December 2020
FL867A
NHTSA #20V-686

Subject: Freightliner Econic SD Battery Cables and Ground Ring Terminal

Models Affected: Specific Model Year 2019-2021 Freightliner Econic SD model vehicles, manufactured June 24, 2019, through October 29, 2020.

Subject: Freightliner Econic SD Battery Cables and Ground Ring Terminal

Fig. 1, Ground Harness, Incorrect Installation

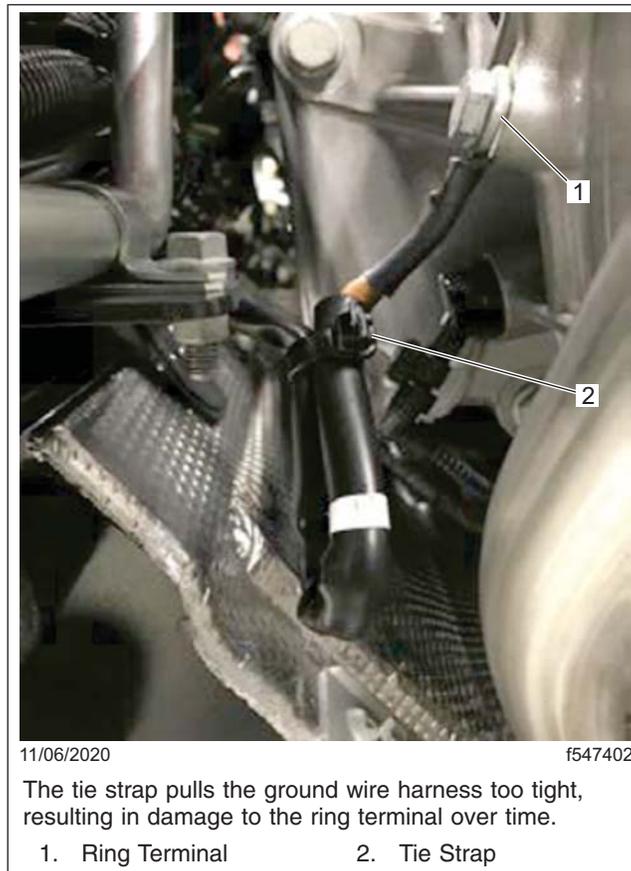
The tie strap may pull the ground wire harness too tight, resulting in damage to the ring terminal over time. See [Fig. 1](#).

2. Park the vehicle on a level surface, shut down the engine, and set the parking brake. Chock the tires.
3. Remove the ring terminal from the negative post and the ground wires.

4. Remove any rubber sleeves from the ground wires, even if undamaged.
5. Clean the ground wires and components, as needed, to remove any dust or debris.

6. Slide a new piece of heat shrink tubing (sleeve) on the ground wires (to be heat shrunk in place after the new ring terminal is soldered).
7. Install a new ring terminal on the ground wires.

8. Solder the two ground wires to the ring terminal.
9. Apply heat to the shrink tubing, sealing it around the ground wires to prevent corrosion.
10. Install the ring terminal on the negative post; torque the M10 nuts to 13.28 lbf-ft (18 N·m).

Fig. 2, Damaged Sleeve at the Relays

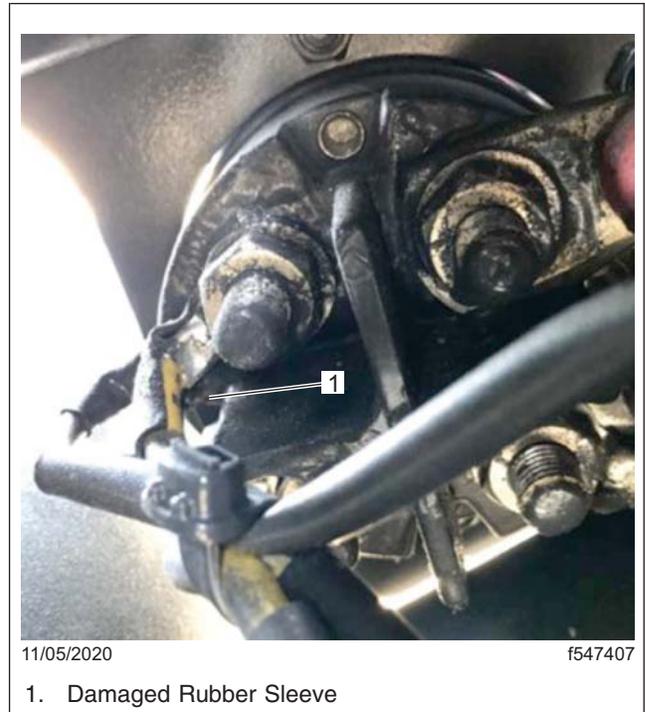
Rubber sleeves on the two relays behind the battery box and at the main battery switch may be damaged due to a combination of the coated corrosion protection wax and high temperatures required during the paint finishing process. See [Fig. 2](#) and [Fig. 3](#).

1. Remove the left battery from the battery box.
2. Remove the red and yellow cables from the relays in the back of the battery box.
3. Remove any rubber sleeves from the cables, even if undamaged.
4. Clean the cables and components, as needed, to remove any dust or debris.
5. Apply heat shrink tubing (sleeve) around the cables and terminals and heat-seal them.
6. Install the cables on the relays. Align all ring terminals so that the positive and negative cables do not cross and are not tied together. See [Fig. 7](#).

Fig. 4, Positive and Negative Cables Incorrectly Tie-Strapped Together

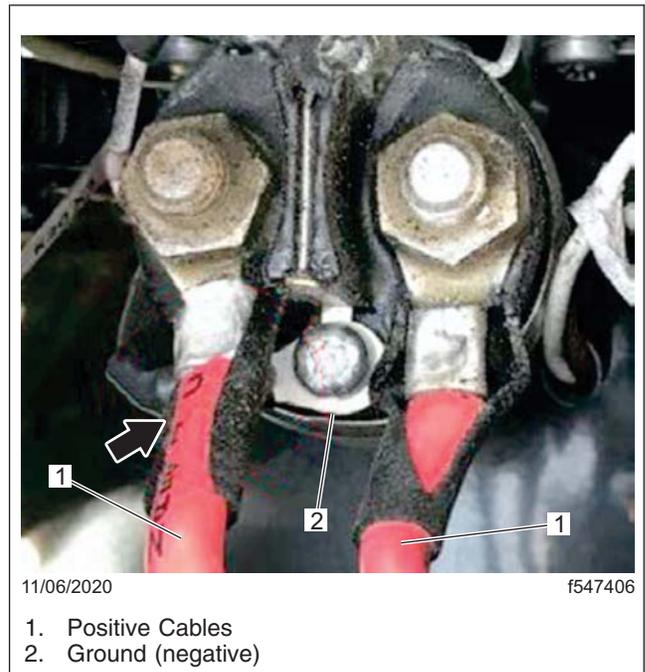
The positive cables may be tie-strapped to the thin negative ground wires of the relays. See [Fig. 4](#).

Fig. 6, Ground Wires, Correct Installation

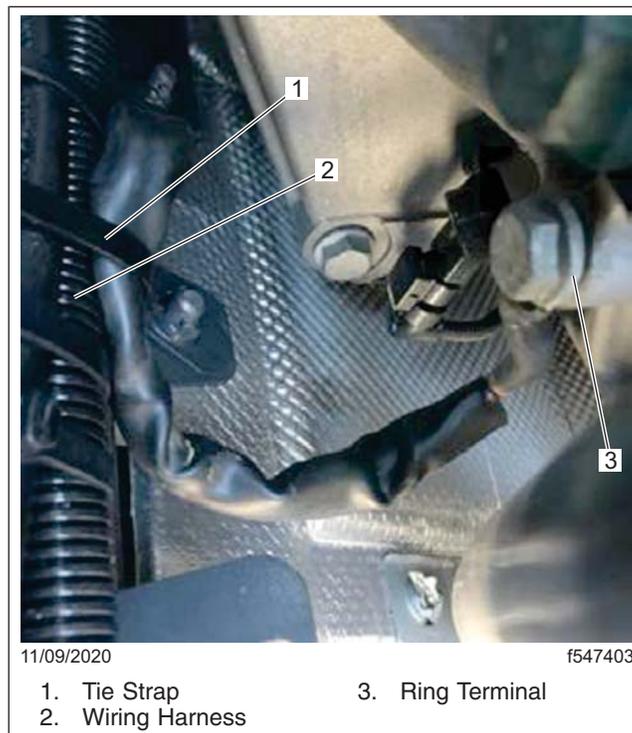
IMPORTANT: Ensure that the ground wires have enough slack to compensate for engine movement and vibration.

11. Use a tie strap to attach the ground wires to the wiring harness convoluted tubing. See [Fig. 6](#).
